**UIC - I - \_11\_**

**MECHANICAL  
INTEGRITY TEST  
(MITs)**

Pursuant to Condition 3.D.1 of the Bloomfield Terminal Injection Well Discharge Permit (UICI-011), Western Refining Southwest, Inc. conducted a pressure test on the Bradenhead and Intermediate casings of WDW #2 on Tuesday, September 17, 2019. A representative of NMOCD was on-site to witness the test. Attached is a copy of the Test Report.

**From:** Perrin, Charlie, EMNRD  
**Sent:** Thursday, February 16, 2017 10:27 AM  
**To:** Hains, Allen; Powell, Brandon, EMNRD; John Thompson; Kuehling, Monica, EMNRD  
**Cc:** Dooling, Frank; Robinson, Kelly; Krakow, Matt; Goetze, Phillip, EMNRD; Griswold, Jim, EMNRD; Chavez, Carl J, EMNRD; Davis, Bruce; Roberts, Dale; Marks, Allison, EMNRD; Sanchez, Daniel J., EMNRD  
**Subject:** RE: Mechanical Integrity Test of Waste Disposal Well #2 - 30-045-35747

CHART PUT ON  
LOCATION  
REMARKS  
WSDW #2 UNIT H  
LINE 1 MINUTE  
MIT CASING TEST  
SLOPS 30 MINUTES

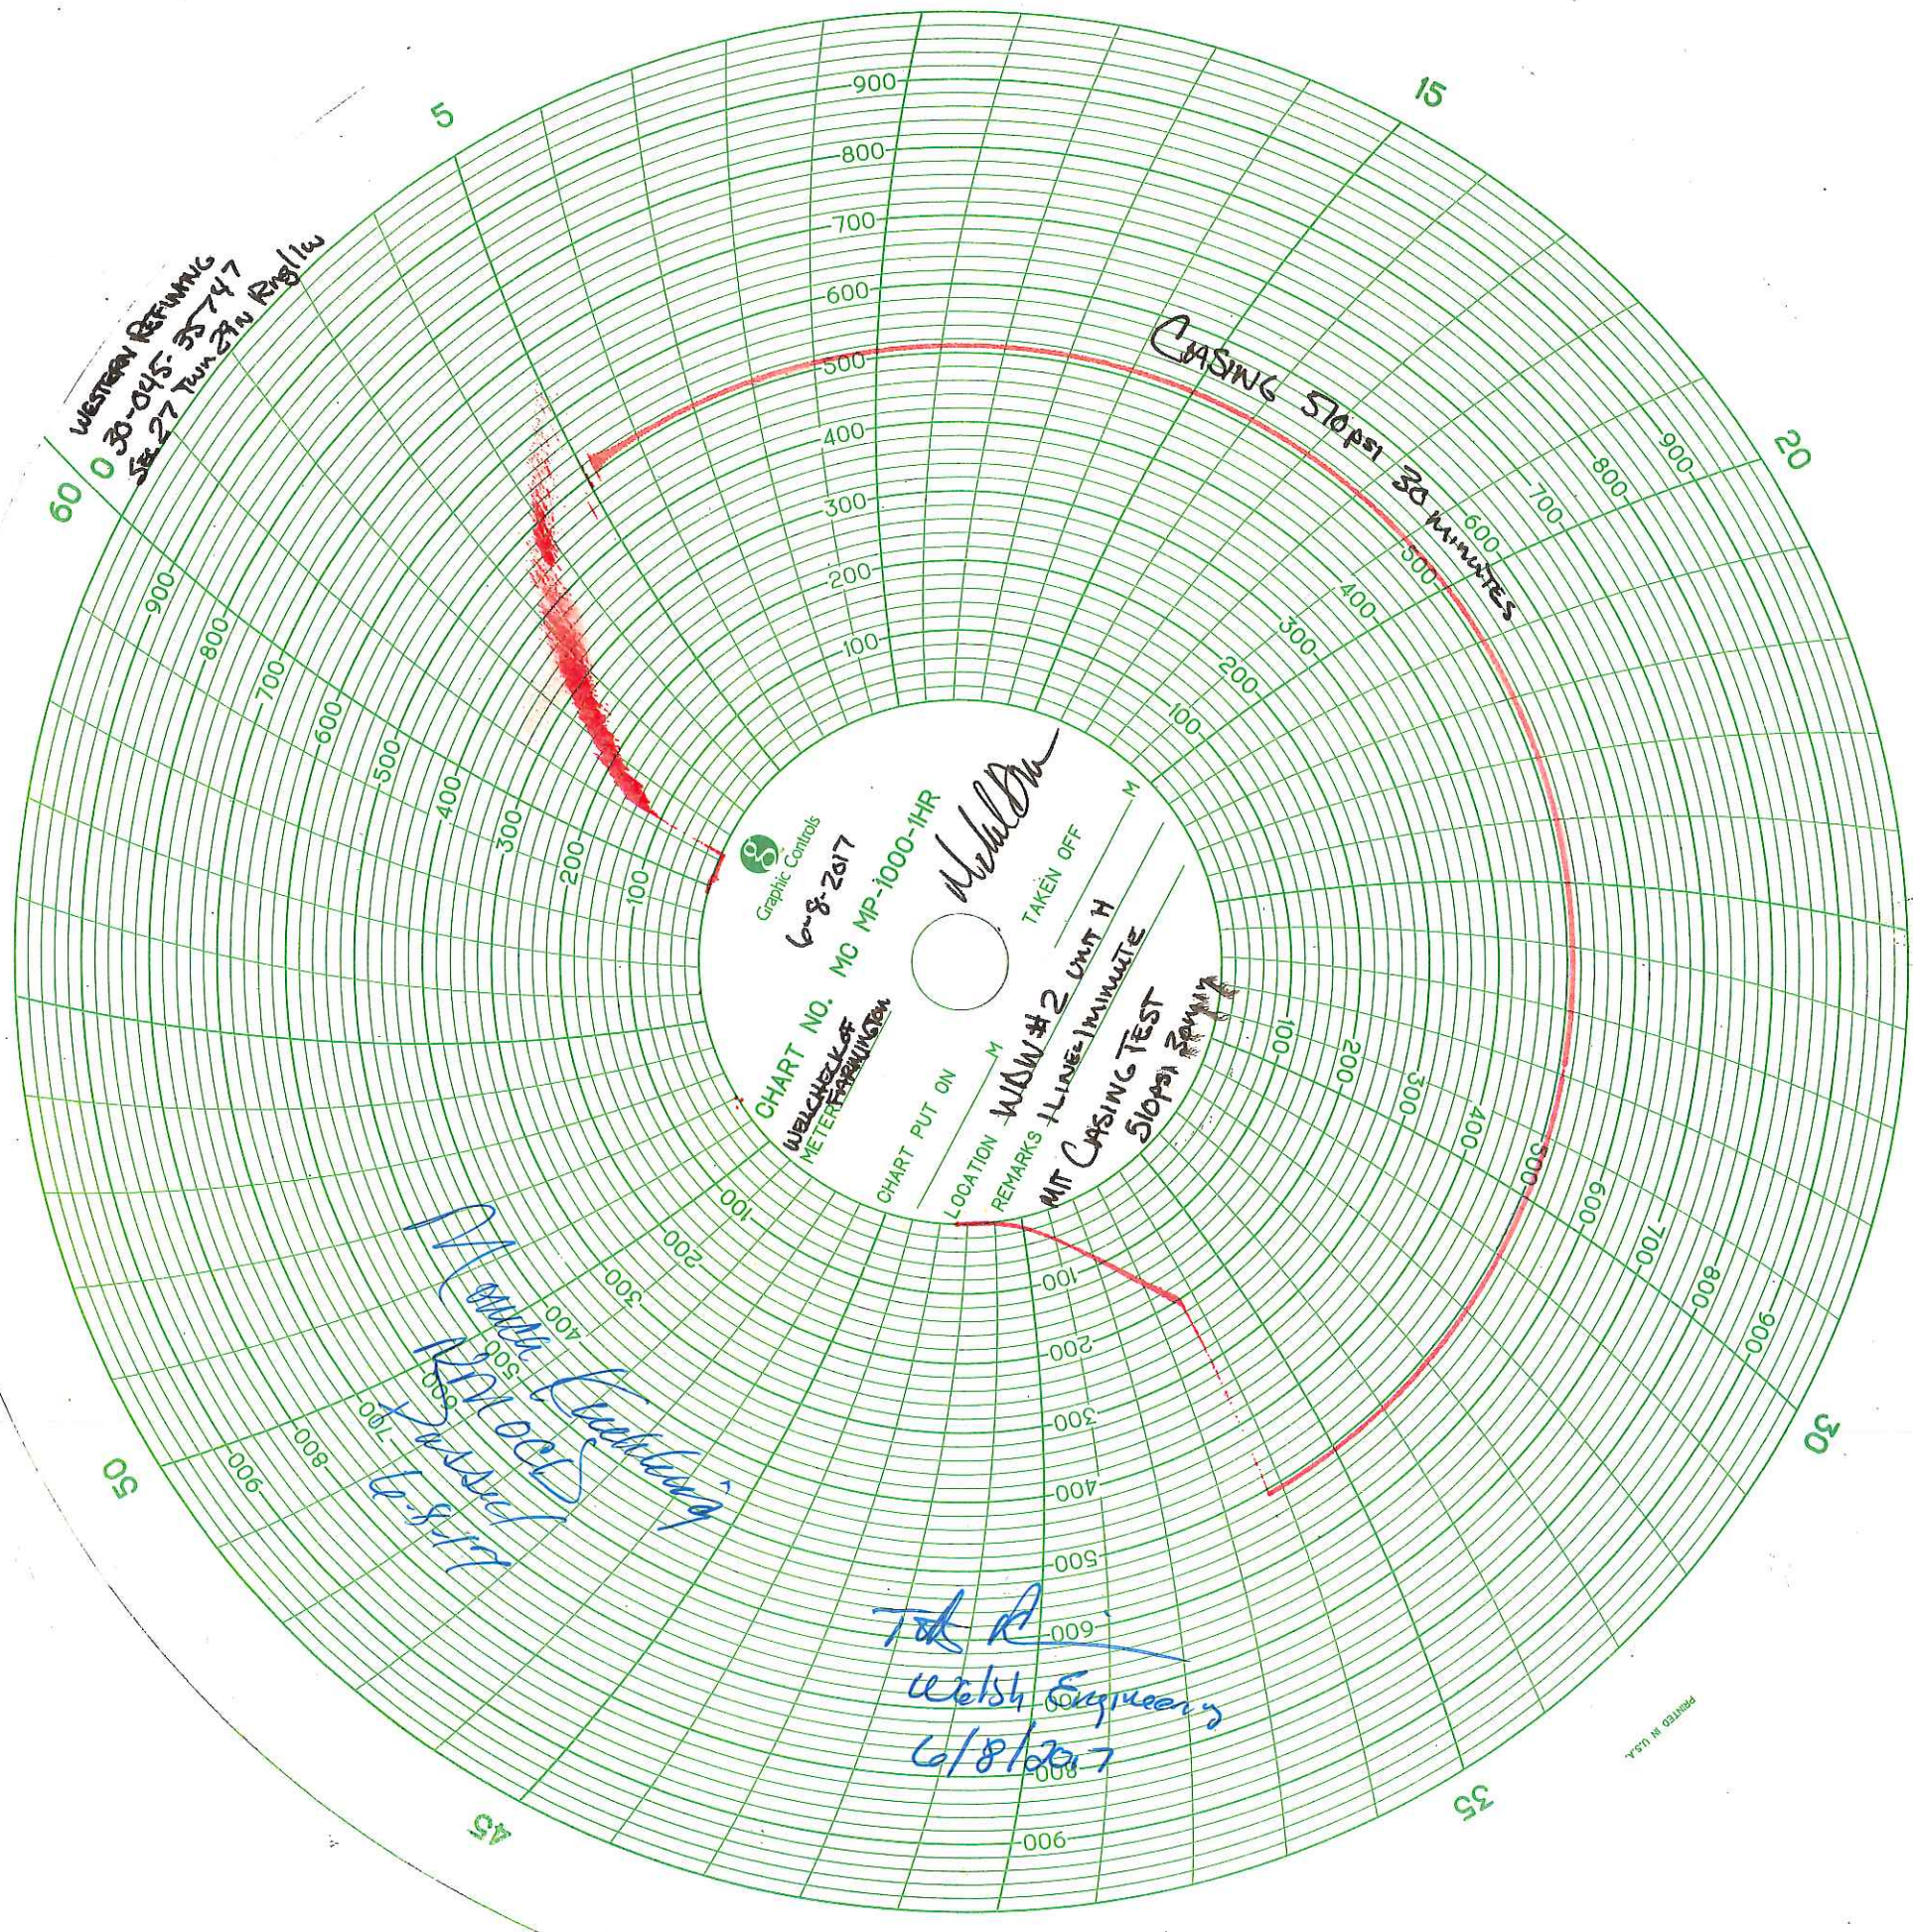
Tubing pressure was not checked or monitored before or during MIT.  
Surface casing pressure was not checked or monitored before or during MIT.  
Intermediate casing pressure was not checked or monitored before or during MIT.

Considering these inadequacies the MIT report and Chart should NOT have been marked as passed officially or unofficially.

The statement on the chart " Retest when injection set up."

The conditions written on the MIT form indicate the test was unofficial and the condition written on the chart states "Retest when injection is set up". These are conditions added to the forms, which Western was explicitly made aware of on the day the test was performed.

After reviewing the well and testing information, OCD District III hereby denies Westerns request and as such a properly conducted MIT and Bradehead test is required prior to beginning disposal operations. Please provide the district a minimum 24 hours' notice prior to testing.
